Product Change Notification: CAAN-09AFAD800

CCB 6887 Final Notice: Qualification of MTAI as an additional In-House Programming (IHP) site for selected M2GL005x, M2GL010xx, M2GL025xx, M2GL050xx, M2GL060xx, M2GL090xx, M2GL150xx, M2S005x, M2S010xx, M2S025xx, M2S050xx, M2S060xx, M2S090xx and M2S150xx device families available in various packages.

PCN Status:Final Notification

PCN Type:Manufacturing Change

Packing Material

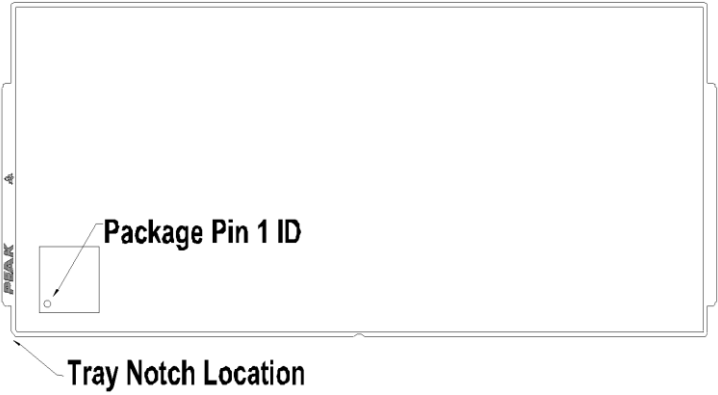
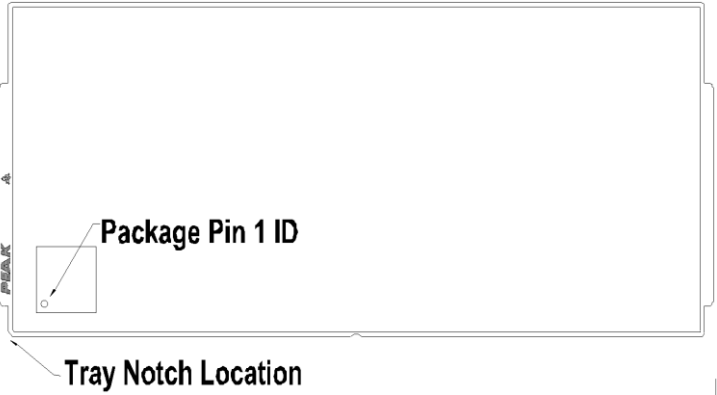
MSCS	MTAI
BQM	1	1
Pin 1 Orientation	 The diagram shows a rectangular tray with a notch on the left side. A small square box in the bottom-left corner is labeled 'Package Pin 1 ID'. A line points from the text 'Tray Notch Location' to the notch on the left side of the tray. The word 'PEAK' is written vertically on the left side of the tray, and the letter 'A' is at the top left corner.	 The diagram shows a rectangular tray with a notch on the left side. A small square box in the bottom-left corner is labeled 'Package Pin 1 ID'. A line points from the text 'Tray Notch Location' to the notch on the left side of the tray. The word 'PEAK' is written vertically on the left side of the tray, and the letter 'A' is at the top left corner.

PACKING METHOD

MSCS

MOISTURE
SENSITIVE
DEVICE

MSID is pre-printed on box

MTAI

MSID sticker is attached.
